# WOLF CREEK

WO 03-0057

Subject: Docket No. 50-482: Revision to Technical Specifications – Extensions of AC Electrical Power Distribution Completion Times

Simplified One-Line Diagram of Sharpe Station Power to WCGS

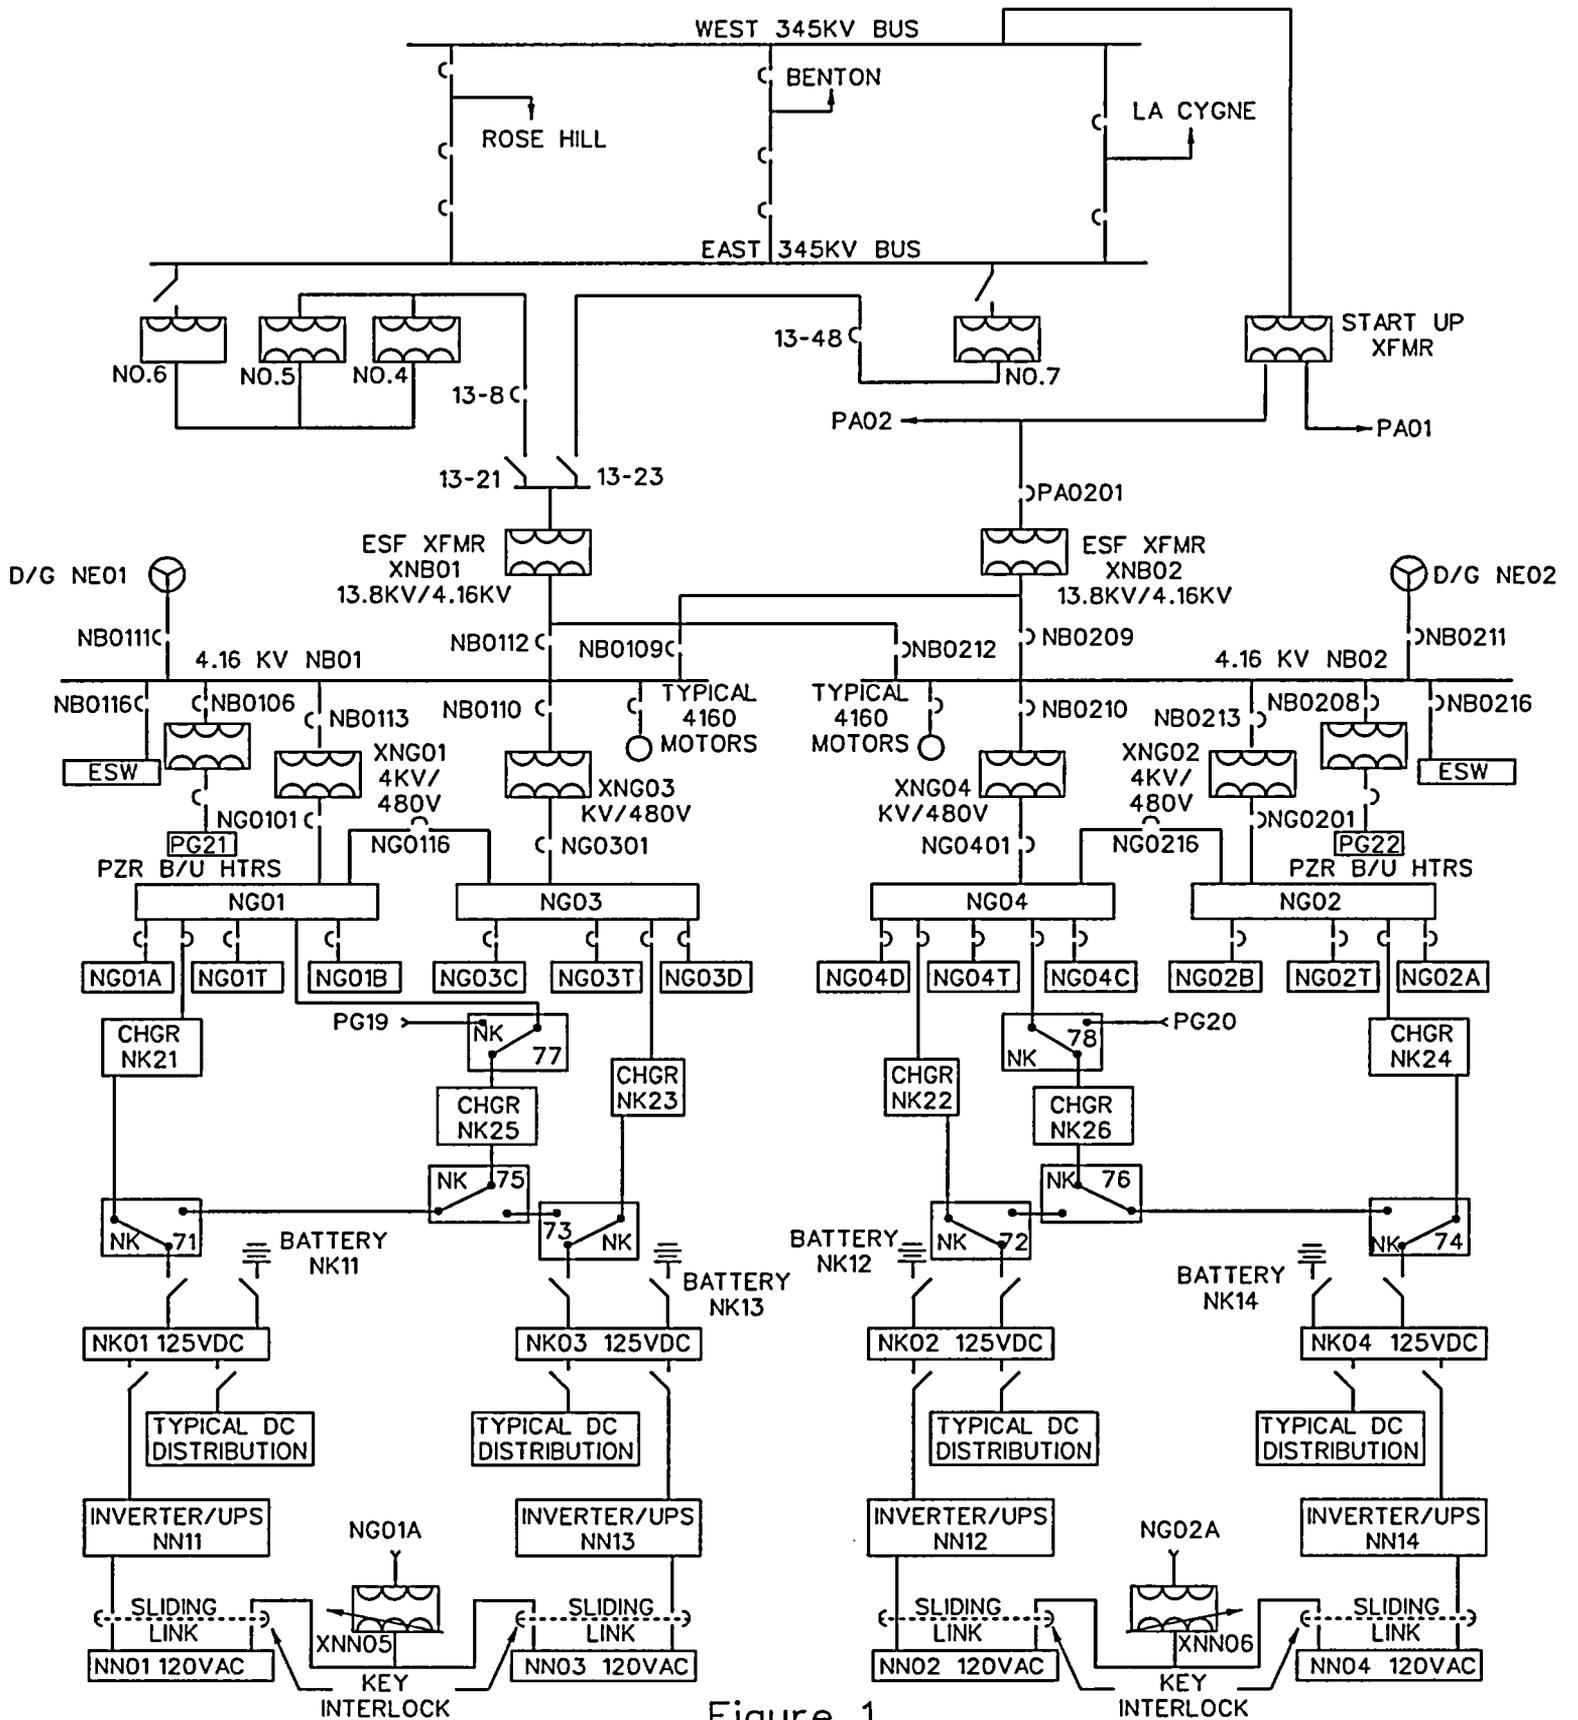
In 2002, Kansas Electric Power Cooperative, Inc. (KEPCo) constructed an electric generating station (Sharpe Station) that consists of ten, two-megawatt Caterpillar 3516B engine-generator sets (gensets). The gensets are sited at a single location near an existing 69 kV substation near Sharpe, Kansas, approximately two miles north of WCGS. Siting it near WCGS provides emergency back-up power for WCGS, specifically, to improve availability and reliability of sufficient AC power for planned or postulated WCGS plant conditions including planned onsite DG maintenance, emergent failure of one onsite DG, complete loss of all onsite emergency AC power, and grid perturbations or loss of a normal offsite power source to WCGS. Currently, Sharpe Station is not an Alternate AC (AAC) power source as defined in Regulatory Guide 1.155, "Station Blackout," (Reference 4) Power from the Sharpe Station enters the WCGS switchyard via the Phillips 69-kV line (see below figure).

In 2002, an additional, nearby offsite power source (Sharpe Station) became available to Wolf Creek. The AC power source may be used during station blackout conditions. The 1998 PRA model was modified to make use of this new capability. Further discussion is included under RAI 5 in Attachment II.

The 1998 PRA model was modified to make use of the Sharpe Station capability. The WCGS model is constructed such that all cutsets that result in station blackout conditions are flagged. This flagging becomes a simple and effective way to consider the impact of having the Sharpe Station available to provide power to the plant through the switchyard.
